FOUNDATION INVESTIGATION REPORT
FOR
AIRPORT ROAD UNDERPASS
W.P. 407-97-01
G.W.P. 290-97-00, SITE 44-382
HIGHWAY 69, DISTRICT 52
HUNTSVILLE, ONTARIO

FOUNDATION INVESTIGATION REPORT

Re: Final Foundation Investigation Reports
Hwy 69 - Four Laning From Tower Rd. Northerly 26.5 km to North of Hwy 141
Blackstone/Crane Lake Underpass, W.P. 408-97-01, Site 44-383
CNR Overhead, W.P. 405/406-97-01, Site 44-381 N&S
Healey Lake Road Underpass, W.P. 400-97-01, Site 44-377
Tower Road Underpass, W.P. 399-97-00, Site 44-321
Airport Road Underpass, W.P. 407-97-01, Site 44-382
G.W.P. 290-97-00, Hwy 69, District 52, Huntsville

Re: Draft Foundation Investigation Reports
Highway 69 - Four Laning
From Tower Road Northerly 26.5 km to 2 km North of Hwy 141
Blackstone/Crane Lake Underpass, W.P. 408-97-01, Site 44-383
CNR Overhead, W.P. 405/406-97-01, Site 44-381 N&S
Healey Lake Road Underpass, W.P. 400-97-01, Site 44-377
Tower Road Underpass, W.P. 399-97-00, Site 44-321
Airport Road Underpass, W.P. 407-97-01, Site 44-382
G.W.P. 290-97-00, Hwy 69, District 52, Huntsville

BOREHOLE LOCATION PLAN AND SOIL PROFILES

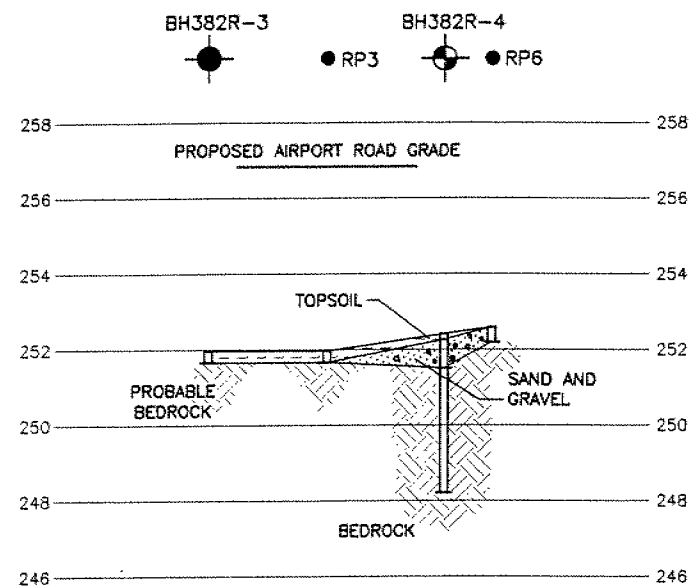
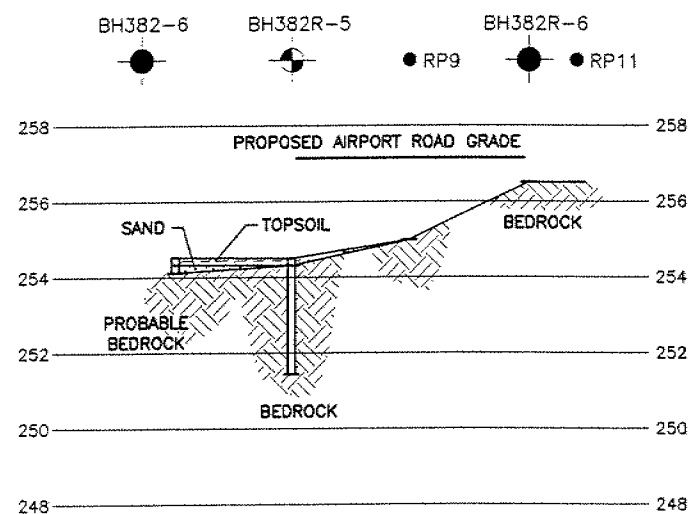
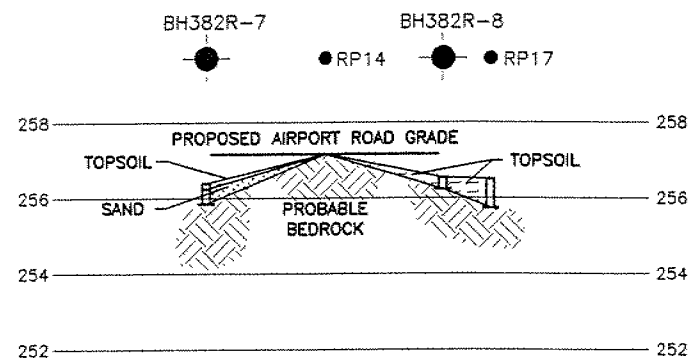
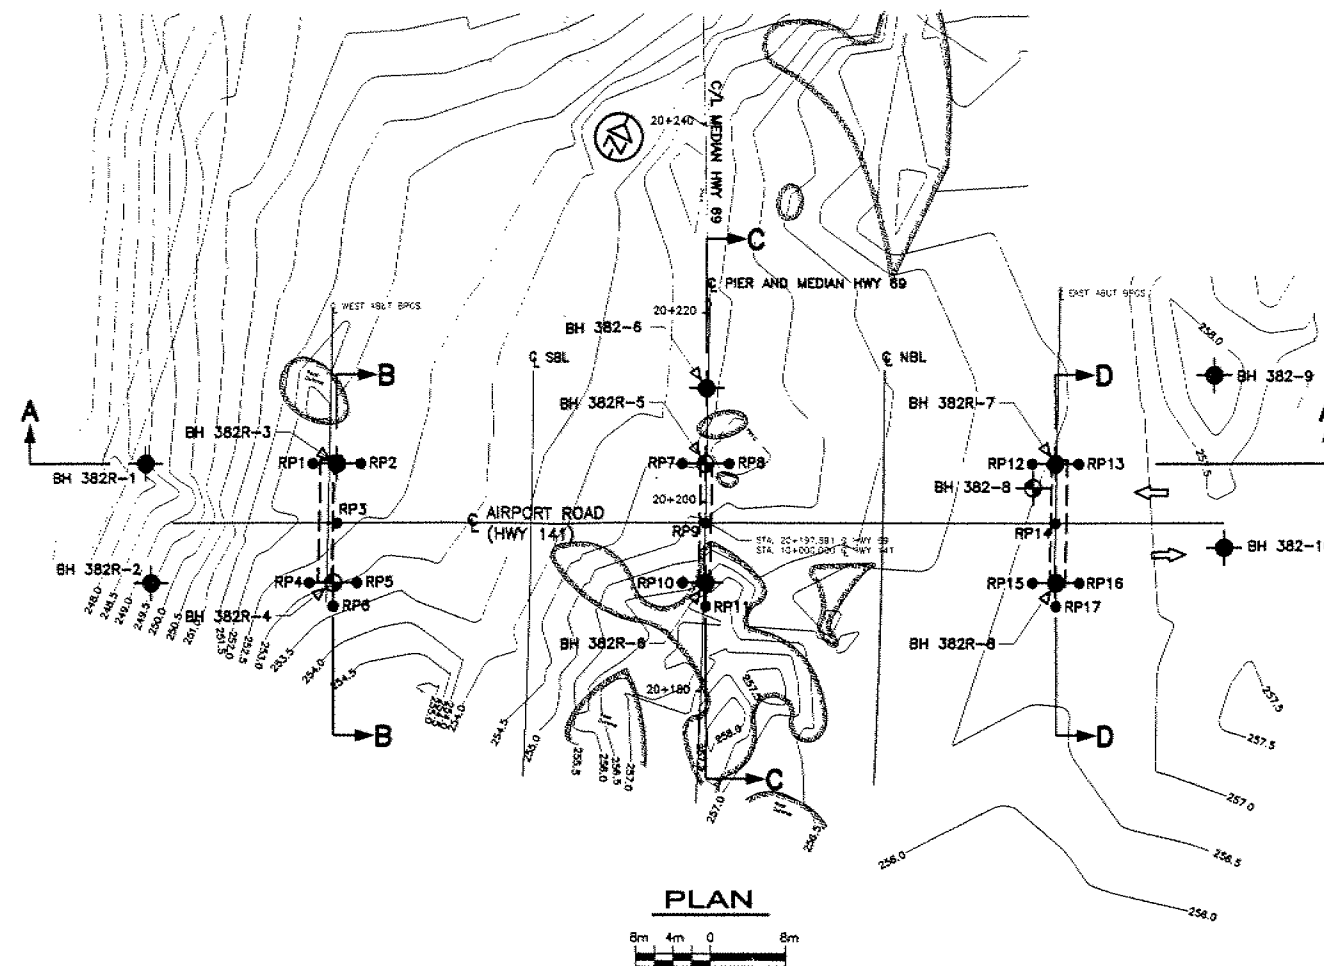
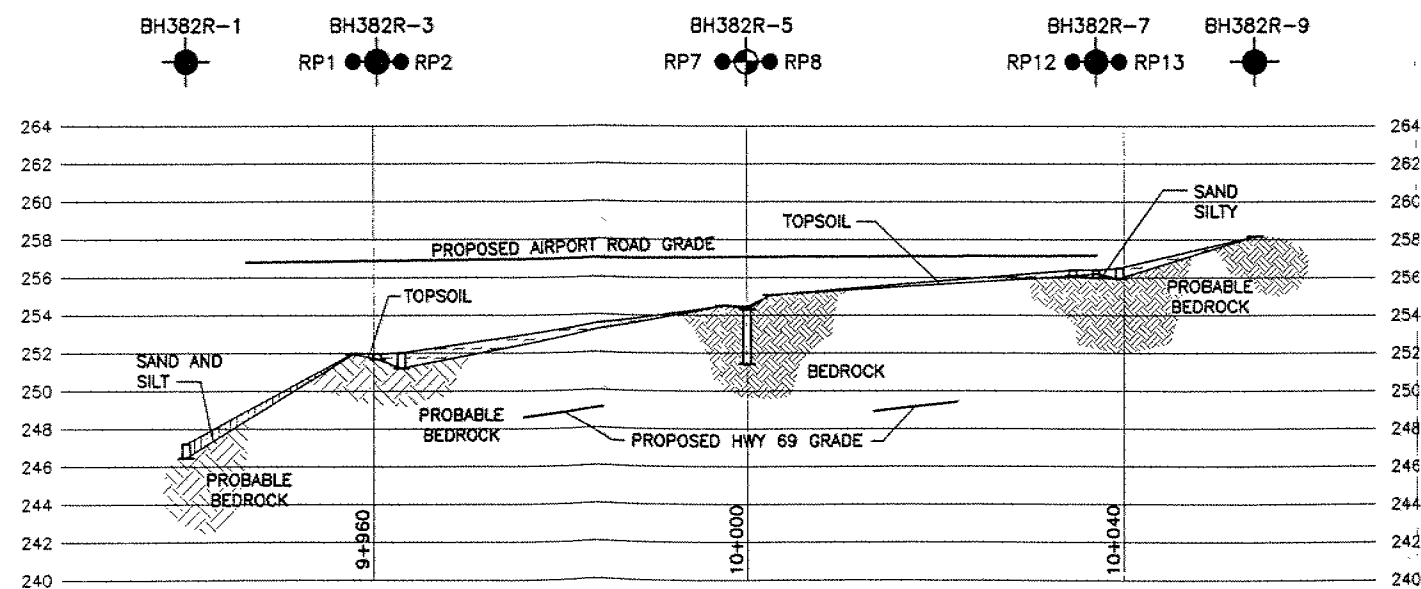
2. Recommendation should be given for the side slopes of the approach fills.
3. The Key Plan, northing and easting and the stations shown on the plan are very small. After the drawings are reproduced to include in the contract package, they would not be legible.

4. The cross sections are very small (some of them are thumb size) and should be enlarged. These cross sections will be included in the contract package. When they are reproduced for the contract package, they would not be legible. The plan is produced in 1:500 scale. The cross sections are normally 100 percent larger than the plans to show the details. But in the report the cross sections are 50 percent reduced. Ideally the cross sections should be in true scale, i.e. same horizontal and vertical scales. If the true scale is not feasible, then the ratio of horizontal and vertical scales should be 2. The ratio of the horizontal and vertical scale in the foundation reports are 5. The cross sections, therefore, are very distorted. All the cross sections do not have to fit on one drawing. Cross sections can be produced on more than one drawings. A sample copy of the standard drawing can be obtained from the Pavements and Foundations office.

5. A bar scale, similar to the one provided on the plan should also be provided on the cross sections
6. The Pavements and Foundations Section has assigned Geocres Numbers for these projects. The Consultant should provide the Geocres numbers on the Final Reports. The Geocres number shall be shown on the lower left corner of the Title Page of the Foundation reports.
